ITEM IV-B: TREE PERMIT – 5 MEDICAL PLAZA DRIVE – SUTTER MEDICAL CENTER – MOB 5 – FILE# 2006PL-141 (TP-000102)

REQUEST

The applicant requests approval of a Tree Permit to encroach into the protected zone radius (PZR) of ten native oak trees (from 1% - 42%) for the construction of a drainage swale associated with the development of the Medical Office Building (MOB) 5 site.

Figure 1

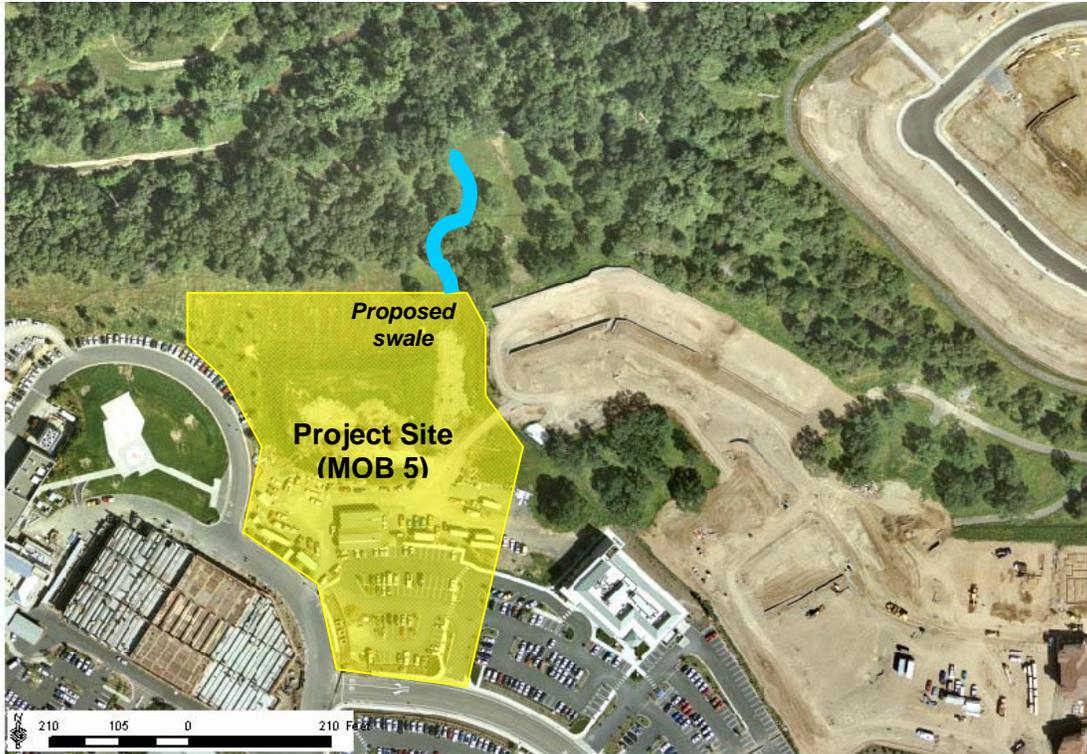
In November of 2006, the Design Committee approved the construction of Medical Office Building 5 (a 60,000 square foot, two-story medical office building with associated parking, lighting, and landscaping). It was required that through the plan check review process the applicant would design the project's drainage plan to minimize off-site drainage and open space impacts. However, after refining the grading plan, the majority of the runoff was still directed to a new storm drain located at the southeast corner of the site (see Attachment 1). The storm drain outfall borders the adjacent open space/oak woodland preserve, and the applicant proposes to construct a drainage swale to convey the discharged water from the storm drain to an existing natural channel located within the oak woodland preserve (see Exhibit A). The proposed swale will encroach into the protected zone radius (PZR) of ten native oak trees. No trees are proposed for removal; however, four of the ten impacted oaks will sustain encroachment exceeding 20%. According to the Tree Preservation Ordinance, approval of a Tree Permit is required where encroachment exceeds twenty (20) percent of the protected zone.
